ISO review of report: “Comparative Economic and Reliability Study Final Report, AV Clearview Transmission Project and Coolwater-Lugo (South of Kramer Upgrade) LGIA Project Reliability and Economic Assessment,” dated February 5, 2013 and submitted by Critical Path Transmission, LLC.

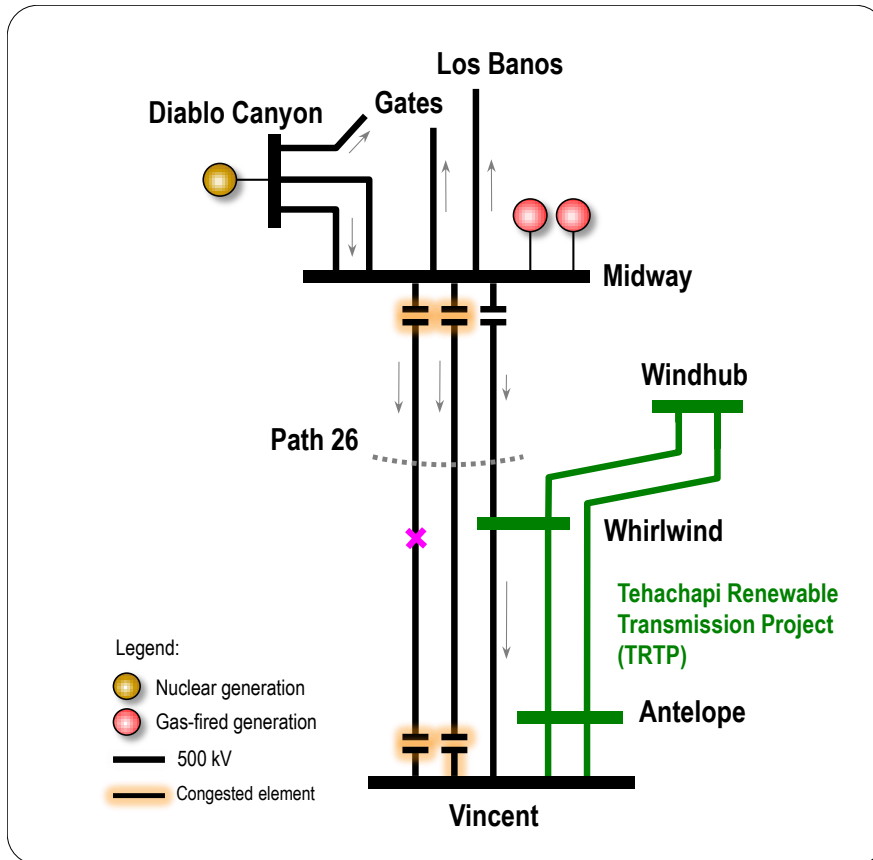
The report's assumption is a critical flaw, as it affects the bulk of the difference in benefits identified in the report attributed to the AV Clearview project in achieving 33 percent RPS by 2020:

- The production simulation economic benefits attributed to the AV Clearview project's impact on Path 26 also reflect in part the incorrectly attributed benefits of providing access to additional generation (Page 14, Table 8, notes 6 through 9)

- It also leads to the incorrect criticism that the Coolwater-Lugo project does not meet the needs of the CPUC base portfolios. (page 13, Table 7, note 5)

- It leads to the erroneous conclusion that the AV Clearview project can interconnect 3 times more generation than the Coolwater-Lugo project. (page 11, item 5)

- It leads to the erroneous conclusion that the Kramer-Lugo transmission would need to be reinforced if Coolwater-Lugo is built instead of the AV Clearview project. (page 21, section 4.4.1)

- It leads to erroneous assumption that additional transmission is required to achieve the CPUC portfolios. (page 22, section 4.5)
- It leads to an erroneous comparison of Resource Adequacy values (page 24, Table 10, first line – 2020 RPS RA Benefit) which would be double-counted in any event if the benefit of avoiding transmission to reach other generation has already been identified as a benefit of the AV Clearview project.
